THE
CHOCOLATE
FACTORY

Purpose of this document

The purpose of this Design and Access Statement Addendum is to present the proposed changes to consented planning application ref HGY/2017/3020 for redevelopment of the sites known as The Chocolate Factory and Parma House, Wood Green. The proposed changes are in the context of the land ownership and relate only to Block E which is proposed to be split into two independent blocks, Block E1 and Block E2.

Land Ownership

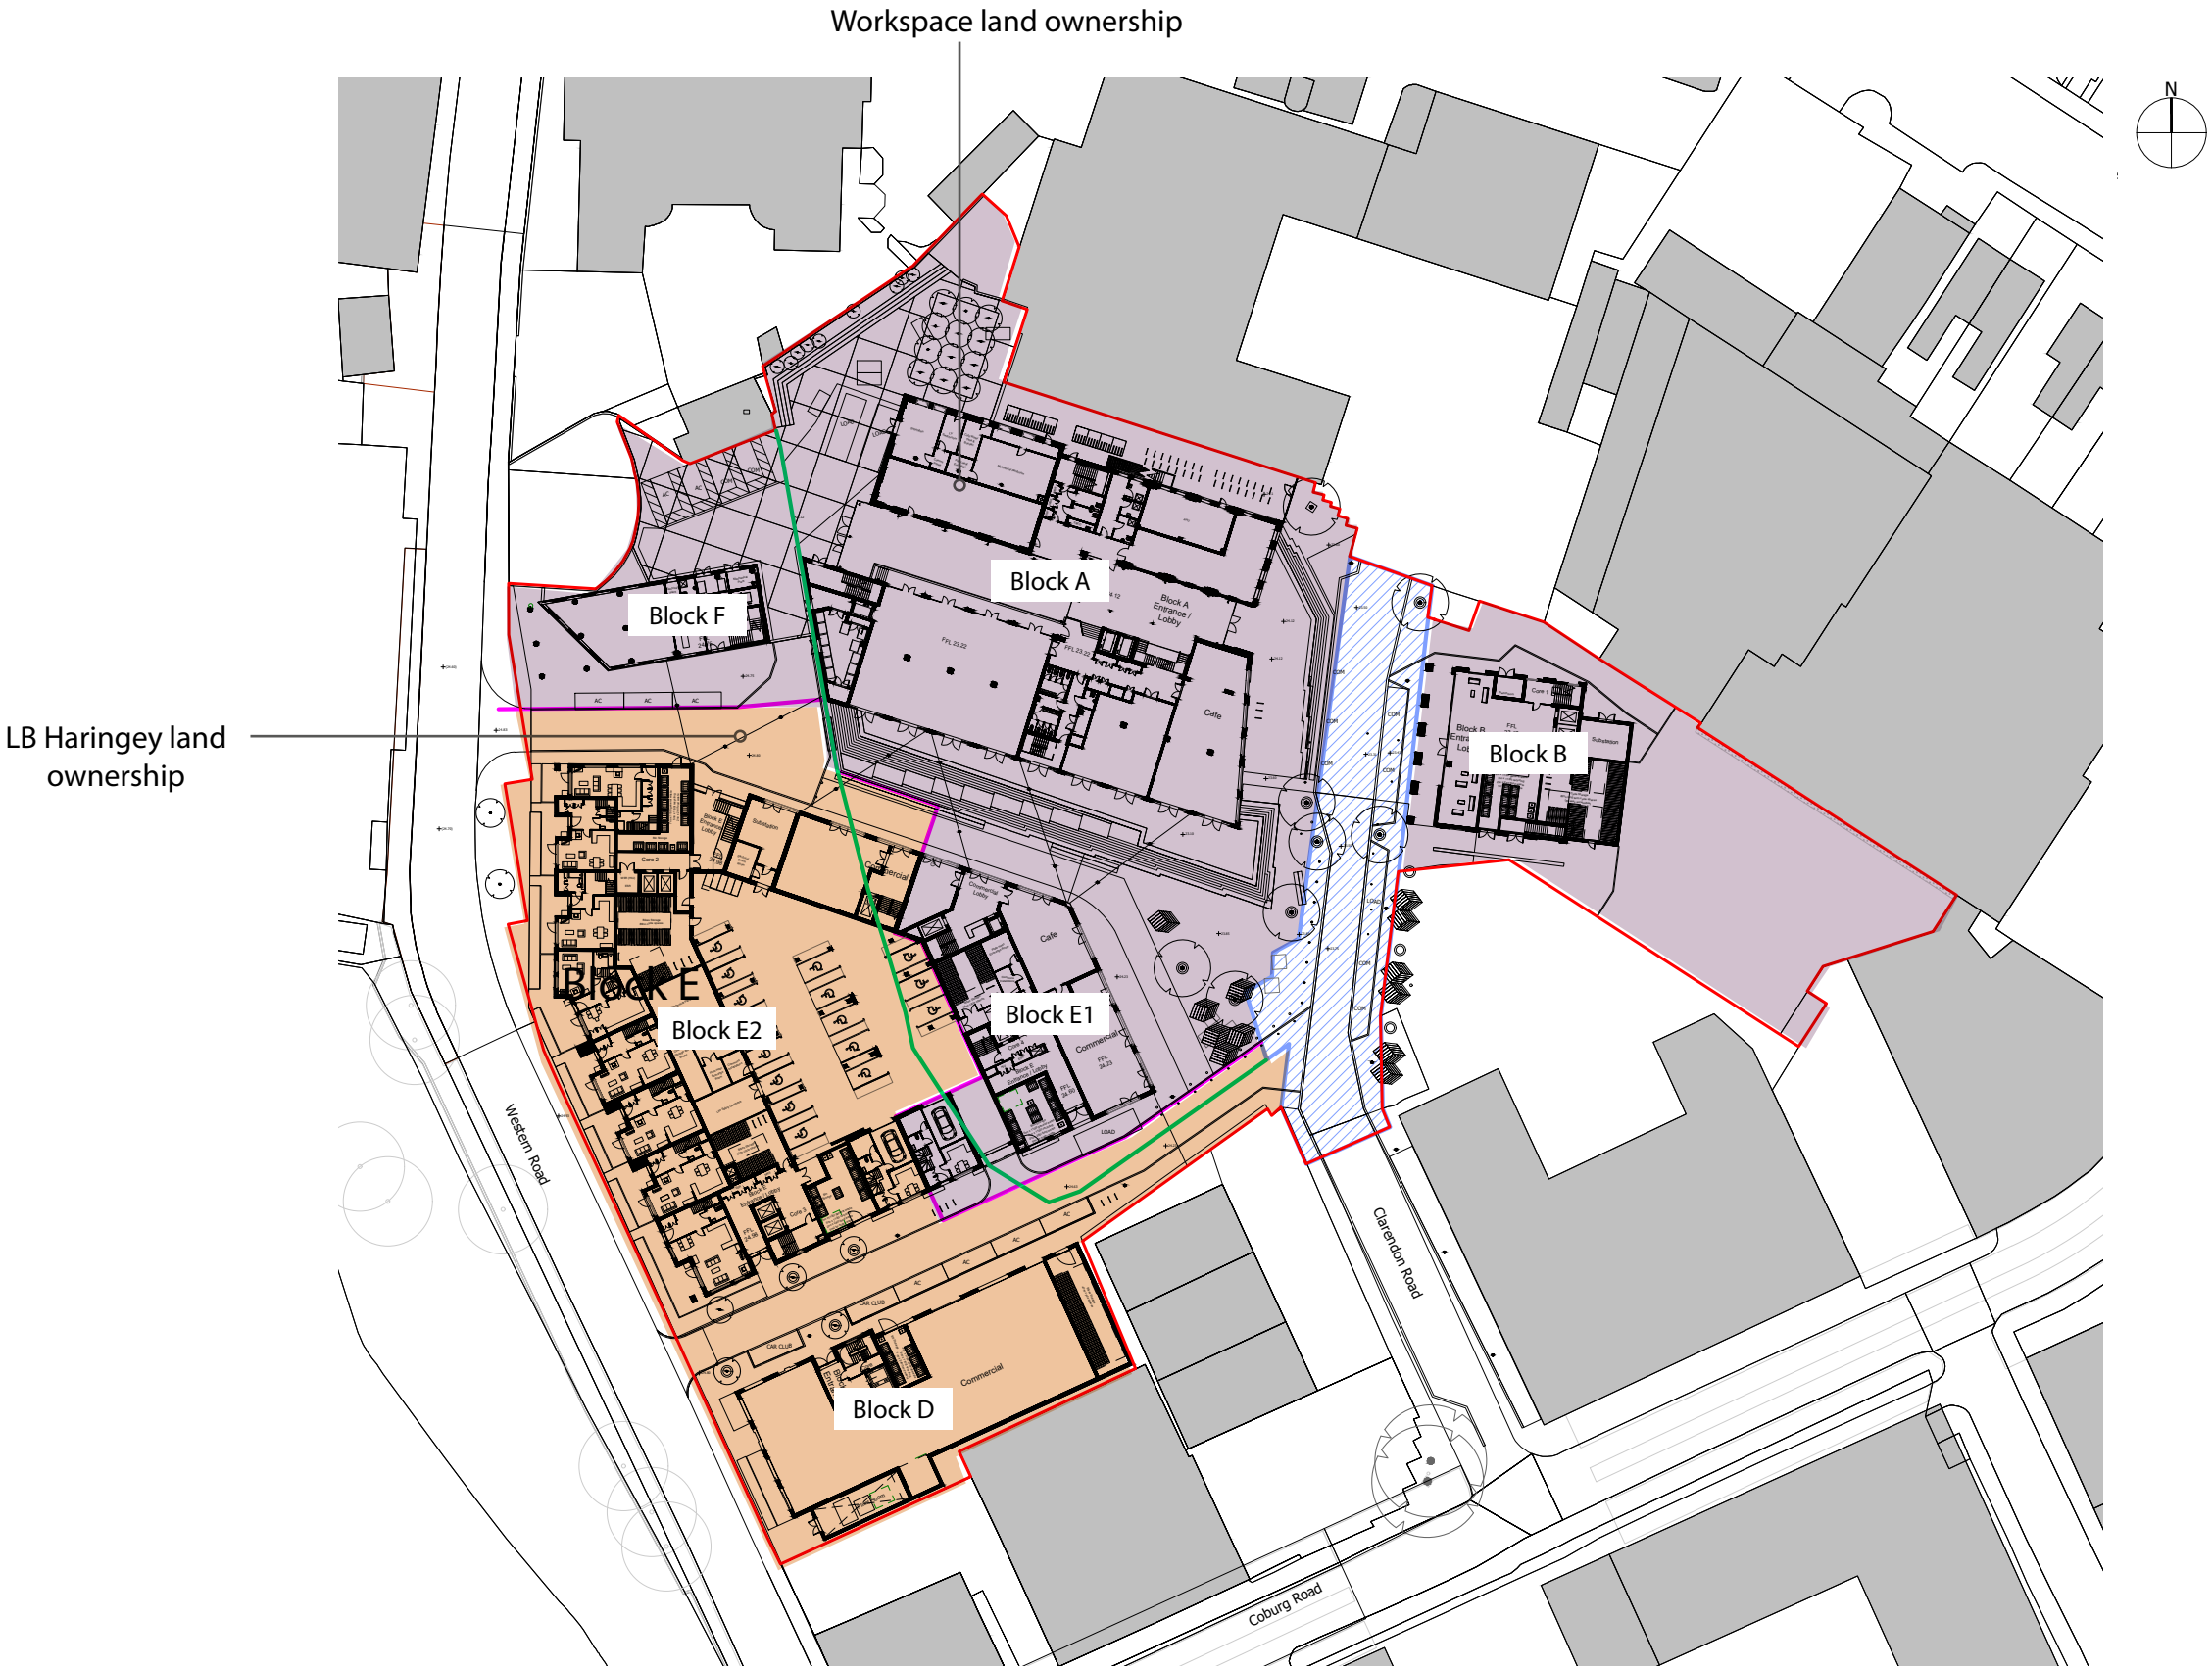
1. Block A (The Chocolate Factory), Block B and Block F fall within Workspace land ownership and therefore there are no design changes proposed to this blocks.

2. Block D falls within LB Haringey land ownership and therefore there are no changes proposed to this block.

3. Block E is now split into two independent buildings, Block E1 within Workspace land ownership and Block E2 within LB Haringey land ownership

DESCRIPTION OF CHANGES. FIFTH FLOOR PLAN

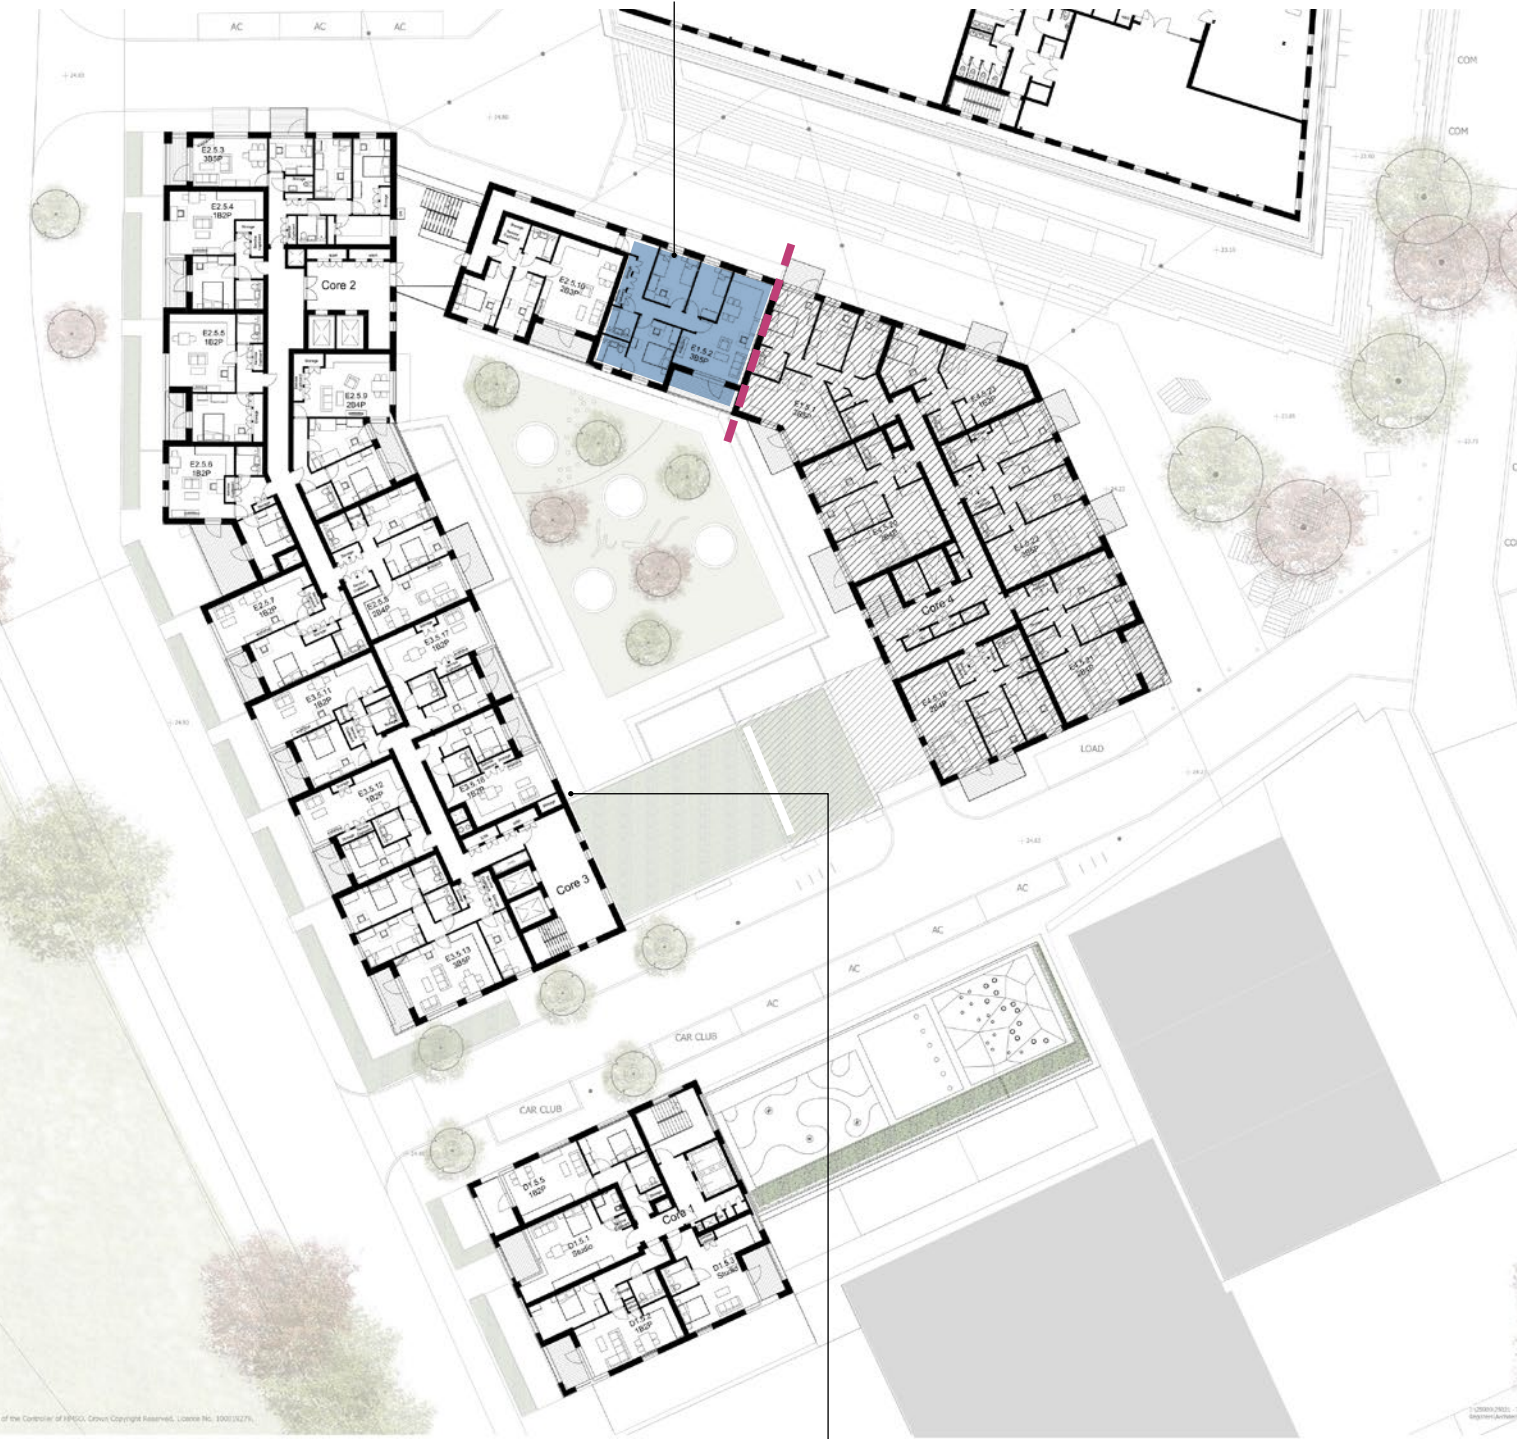
Commercial space:
To facilitate the split of Block E to Block E1 and Block E2
the highlighted party walls required minor alteration.

Party wall width increased. As a result unit area of E1.5.2
changed from 95.6sqm to 94.6sqm

Please see Proposed Strategy/ Design Principles note, point 9
